**Recommended Regional Amendments to the  
2021 International Swimming Pool and Spa Code**  
North Central Texas Council of Governments Region

**Recommended Amendments to the  
2021 International Residential Code**  
North Central Texas Council of Governments Region

**\*\*Figure R602.6.1; delete the figure and insert the following figure:**

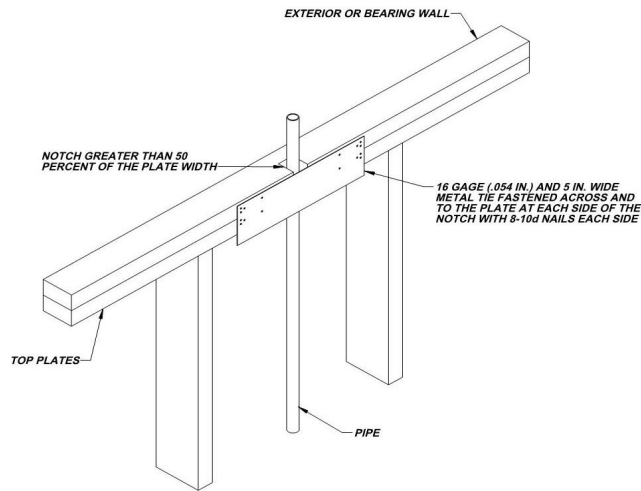
**R602.6.1 Drilling and notching of top plate.** When piping or ductwork is placed in or partly in an exterior wall or interior load-bearing wall, necessitating cutting, drilling or notching of the top plate by more than 50 percent of its width, a galvanized metal tie not less than 0.054 inch thick (1.37 mm) (16 Ga) and ~~4 ½ inches (38) mm~~ 5 inches (127 mm) wide shall be fastened across and to the plate at each side of the opening with not less than eight 10d (0.148 inch diameter) having a minimum length of 1 ½ inches (38 mm) at each side or equivalent. Fasteners will be offset to prevent splitting of the top plate material. The metal tie must extend a minimum of 6 inches past the opening. See figure R602.6.1. {remainder unchanged}

(Amendment to 2015 IRC carried forward to 2018 IRC also provides additional assurance of maintaining the integrity of the framing by spreading the nailing pattern.)
